Technical change to Dekafix 8 standard print

- PCN-number: PCN-PKD800-20200602-00-A
- date of publishing: 02. June 2020
- duration of validity: unlimited
- revision number: none

Old version	New version

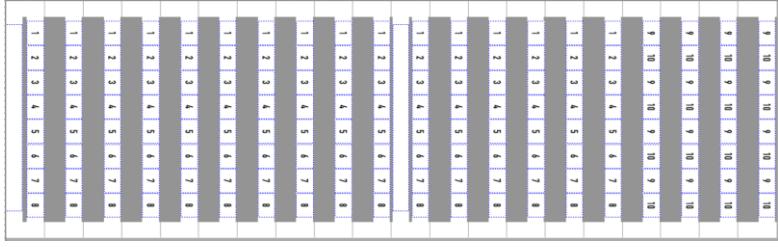
Switch from the old card format to MultiCard:

- The old card format consisted of 5 strips with 10 markers each. One packaging unit contained 10 cards each.
- The MultiCard format for the DEK 8/5 Plus variants consists of 20 strips with 8 markers each. One packaging unit contains 5 MultiCard each.
- This changes the order of the imprint (see the example of the sketch) and the quantity of a packaging unit from the current 500 pieces to 800 pieces
